Groundwater Application Review Summary Form

Application # G- 19449

PUBLIC INTEREST REVIEW FOR GROUNDWATER APPLICATIONS

TO: Water Rights Section Date November 8, 2024
 FROM: Groundwater Section Gabriela Ferreira
 Reviewer's Name
 SUBJECT: Application G- 19449 Supersedes review of _____
 Date of Review(s) _____

Water-Level Measurements in Nearby Wells

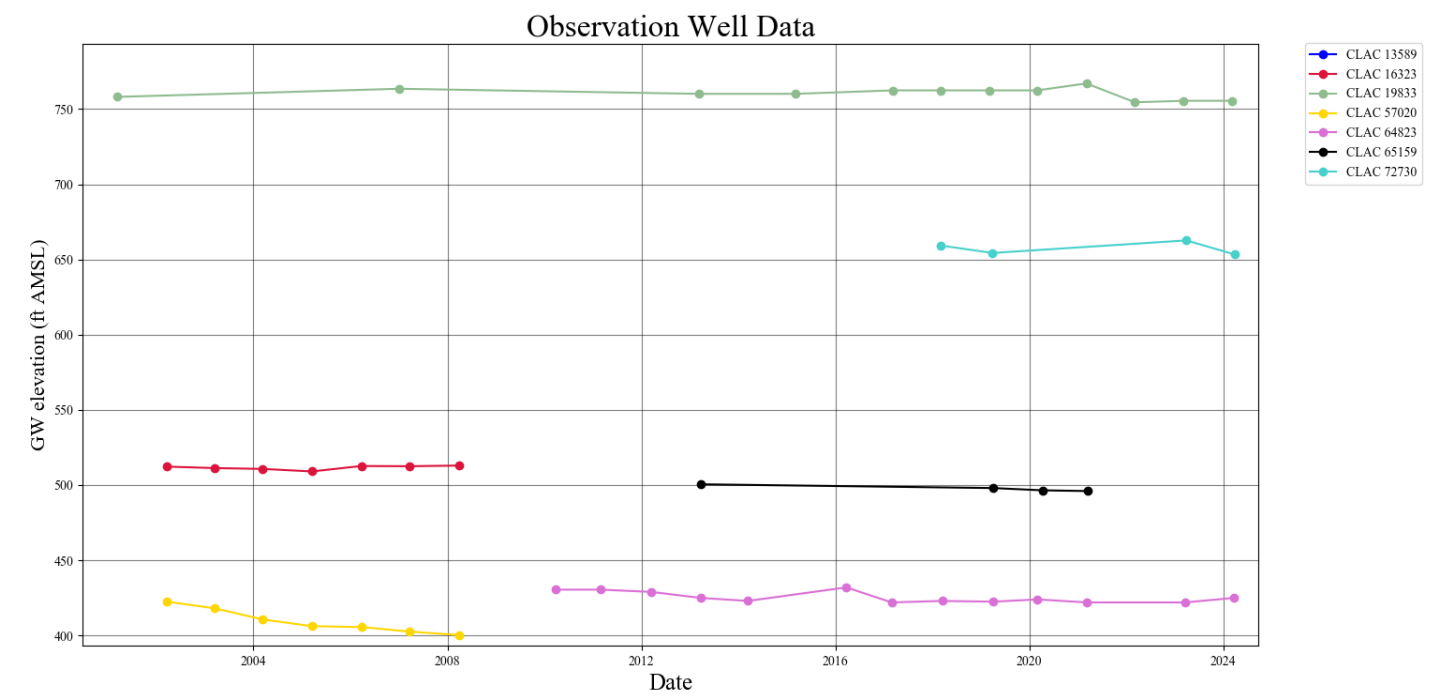
Water level data from six nearby wells were selected for evaluation based on proximity and similar construction. Water levels in one well (CLAC 57020) declined approximately 20 feet from 2002 through 2008. The other wells have generally stable water levels over the available record, with less than 10 feet of variation observed. Available and applicable groundwater level data suggests that groundwater for the proposed use is not over appropriated.

Permit condition 7RL is recommended to assess potential future injury concerns, and as a means to monitor long-term groundwater conditions in this area.

Theis Interference Analysis

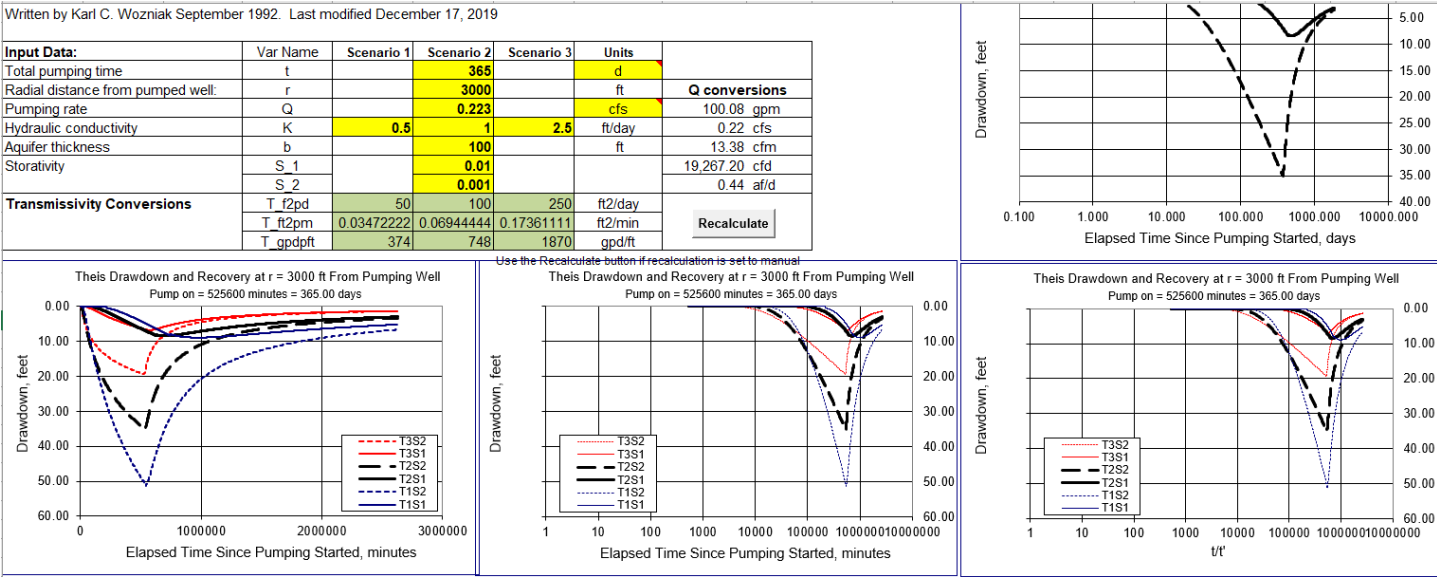
The nearest groundwater user was identified as CLAC 72302, located approximately 3,000 feet northwest of the proposed POAs. Additional wells may be located closer, given the presence of residences, although a well report was not identified. CLAC 72302 is a domestic well completed to a depth of 120 feet bls and sealed to 60 feet bls and a reported water level of 68 feet bls at time of drilling (2016). Despite not fully penetrating the alluvial aquifer system, potential impacts on CLAC 72302 were modeled using the attached Theis drawdown analysis and assuming the full duty and rate of the proposed POA. Transmissivity values are based on pump tests from nearby alluvial wells. Under the most conservative parameters modeled, drawdown may temporarily reach up to 50 feet bls. It appears unlikely that interference in excess of the typical permit

condition limits (Condition 7RL) would occur at CLAC 72302 as a result of the requested withdrawal.
